Supplier Deviation Disposition Request

PROJECT: River Protection Project Waste Treatment Plant

FOR RPP-WTP USE			
RPP-WTP SDDR No. 24590-WTP-SDDR-MS-ID-00144	Rev. N/A	DATE RECEIVED 12/20/2010	
FOR SUPPLIER USE			
SUPPLIER SDDR No. 593-SDDR-004 Rev 0		DATE SUBMITTED 12-22-10

Title of SDDR: Plate Thickness for HOP-HX-00002/4

<p>Drawing No. - SPW-100/06 Rev.0</p> <p>PROOF TEST ARRANGEMENT DRAWING MODEL - SPW-100/0.6mm</p>	SCALE		DRAWN BY	US	CHECKED BY	SN	APPD. BY	SN	DATE	27.07.09
SCALE												
DRAWN BY	US											
CHECKED BY	SN											
APPD. BY	SN											
DATE	27.07.09

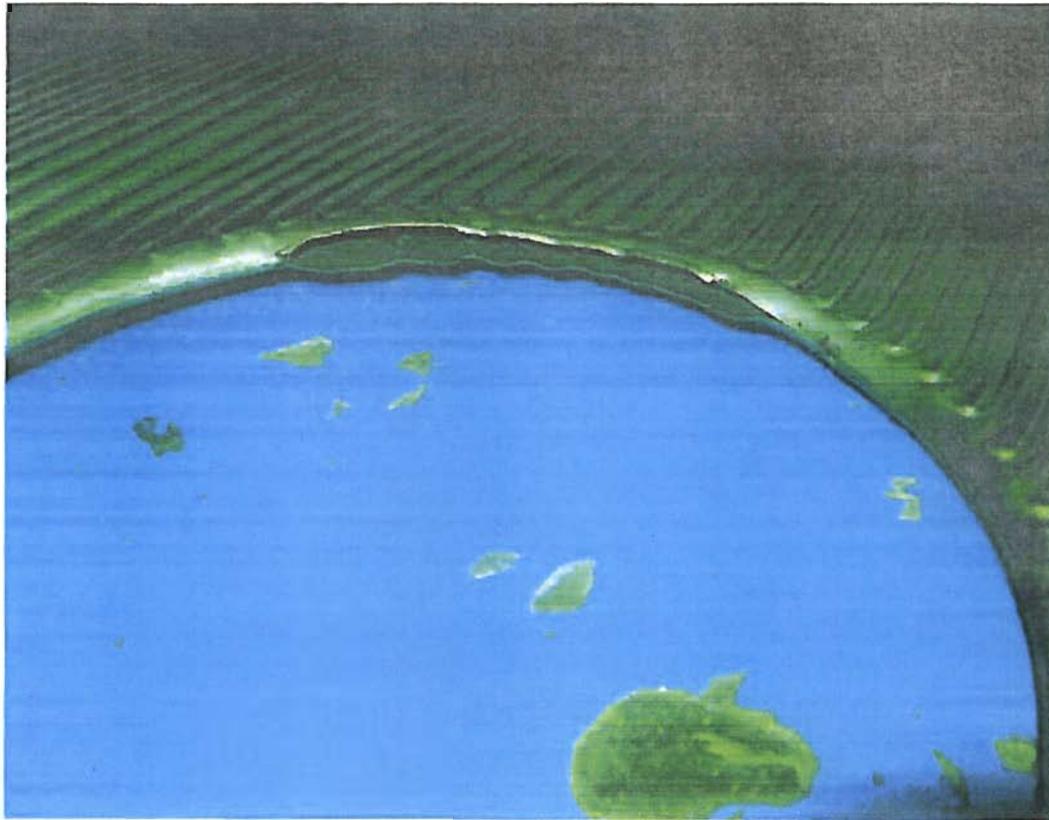
4. Deviation Description (Attach extra sheets, photographs, sketches, etc. as necessary and identify quantity and serial numbers as applicable) S.A. Technology is proposing to deviate from BNI Specification 24590-WTP-3PS-MEP0-T0001 "Plate and Frame Heat Exchangers" Section 3.2.3 "After pressing the minimum thickness of plates shall be 0.024 inch."			
4a. Was an NCR issued? <input checked="" type="checkbox"/> No <input type="checkbox"/> Yes Number:

6. Supplier's Estimated Cost Impact: \$0.00		7. Supplier's Estimated Schedule Impact: None	
8. Proposed Disposition and Technical Justification (plus Cost/Schedule if applicable): (Attach extra sheets, sketches, etc., as necessary.) S.A. Technology is proposing the following change: Section 3.2.3 "Before pressing the minimum plate thickness shall be 0.6mm / 0.0236 inch." Technical Justification There is no corrosion allowance for the plate side, per MDS 24590-HLW-MED-HOP-00031 Rev 0. For Plate Heat Exchangers (PHE) the MAWP is established through burst tests and not calculations. MAWP for welded PHE is based on a safety factor exceeding 5:1 against burst pressure. Attachment 1 is a copy of the burst test for the plates being used for these particular Heat Exchangers. Based on the max operating pressure in the MDS, 5psig and the MAWP results from Attachment 1, 65.26 bar g / 946 psig, the plate cassettes will have a safety factor of 189:1. There for using plates with a before pressing minimum plate thickness of 0.6mm should be acceptable for this application.

Approved
 Exception is granted from 24590-WTP-3PS-MEP0-T0001, Section 3.2.3. Specifically, the plates used for HOP-HX-00002 & HOP-HX-00004 may be constructed from 0.6 mm (0.0236 in.) thick plates.

RPP-WTP Justification (Attach extra sheets, sketches, etc., as necessary).
 Attachment I, *Burst Test for 0.6mm HX Plates*, indicates that the 0.6 mm plate achieves a burst pressure of 427 bar (6193 psi) with a corresponding MAWP of 65.26 bar (946 psi). This MAWP is greater than the Design Pressure specified on MDS 24590-HLW-MED-HOP-00031 of 5 psig.
